Co3237 Poultney BF 0145(13)

ADDENDUM #1

- Invitation for Bids, and Proposal to extend Bid Opening to June 13, 2025, and update the Schedule of Items.
- Special Provision Pages 1 and 6.
- Plan sheets 3, 10, 11, 44-52, 57, 63, 65, 79-82, 93, 94, 96, and 97.
- New Impact Plans shall replace Pages 136 to 171 in the Proposal.

FILE NAME: z21j164floorbeam.dgn
PROJECT LEADER: J.D. KEENER
DESIGNED BY: N.A. TRUSLOW
FLOORBEAM ASSEMBLY DETAILS

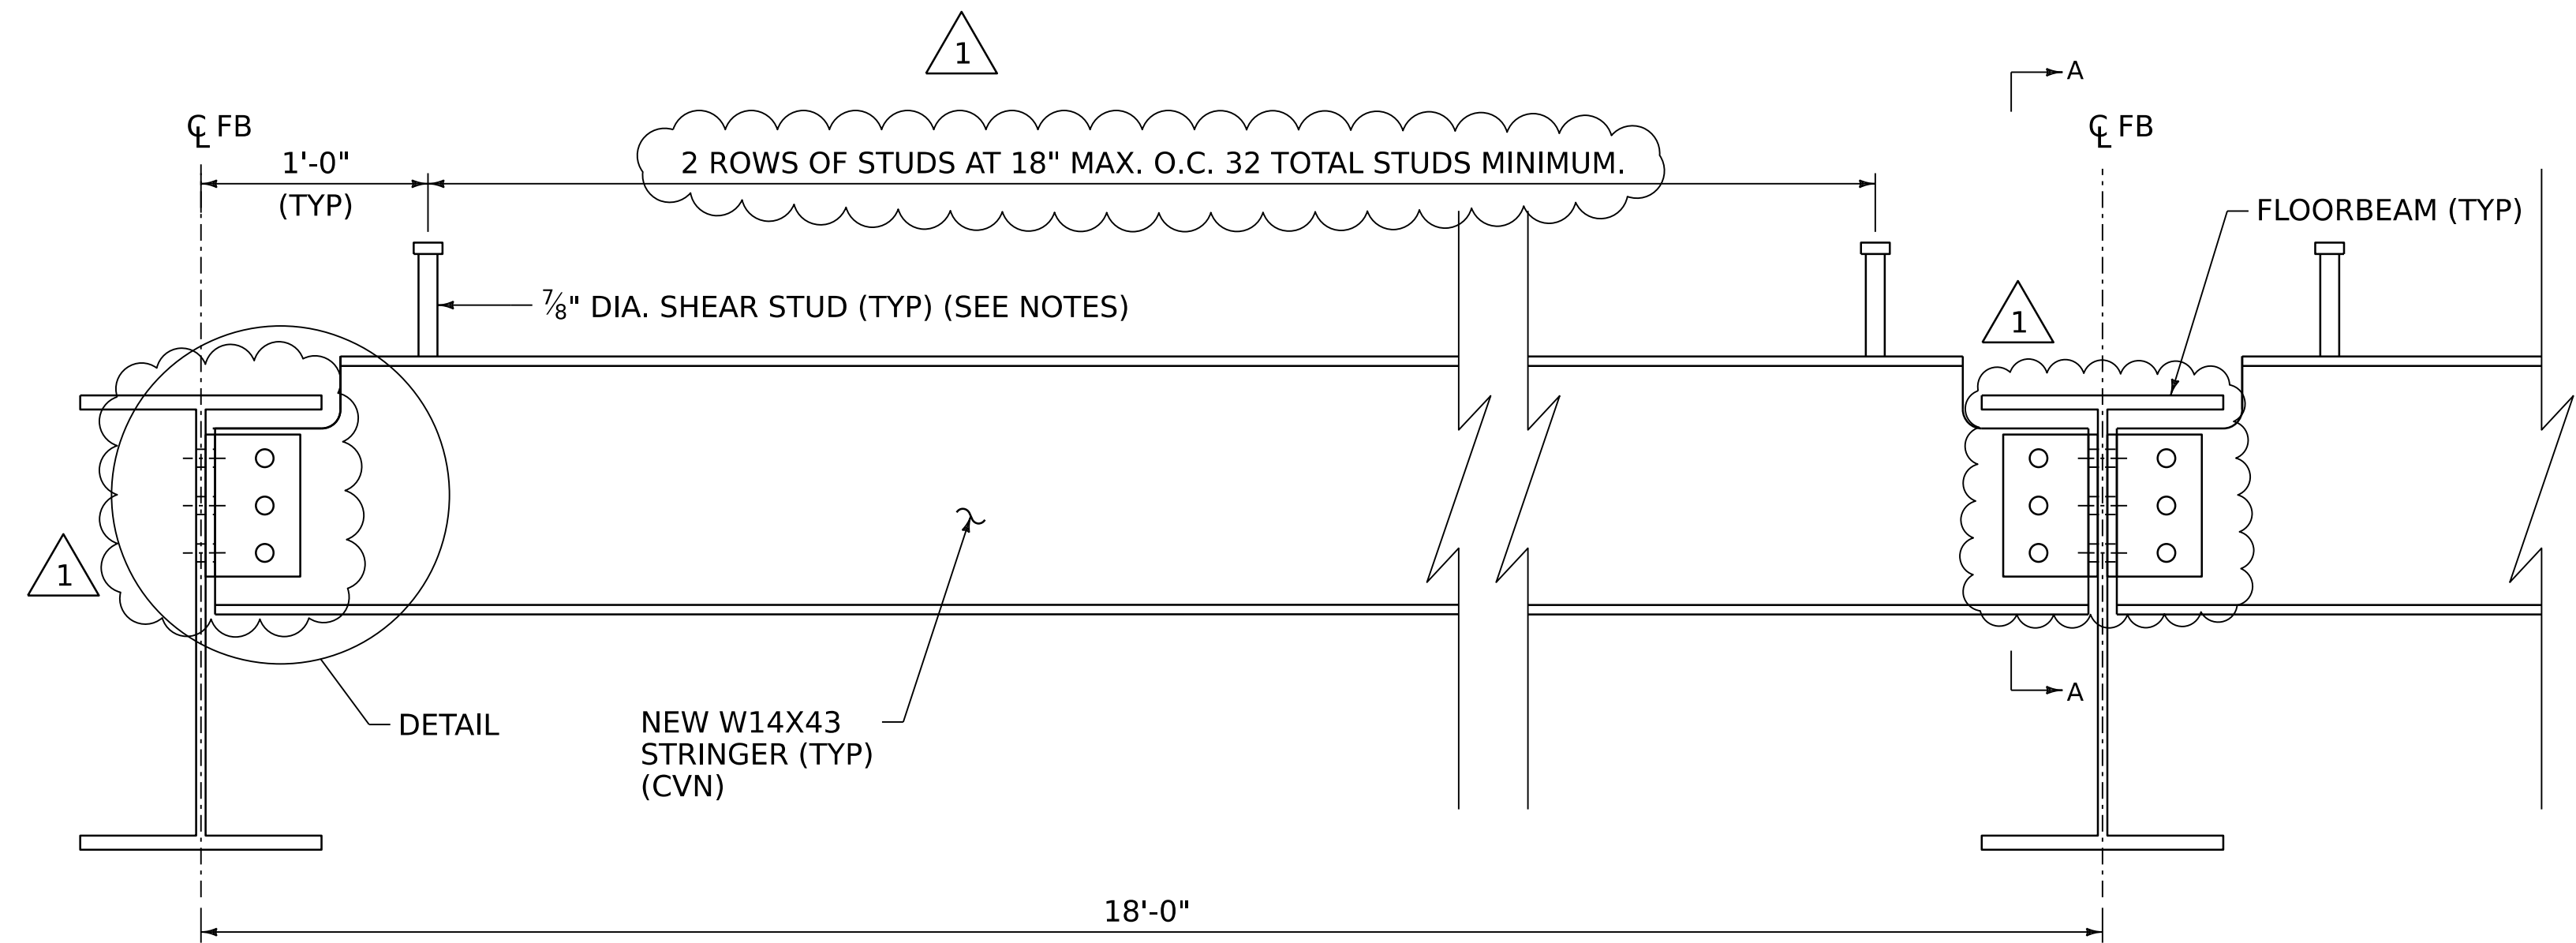
ADDENDUM	REVISION	PLOT DATE	DESCRIPTION	BY
1	1	5/20/2025	REVISED FLOORBEAM AND STRINGER CONNECTION ANGLES	NAT
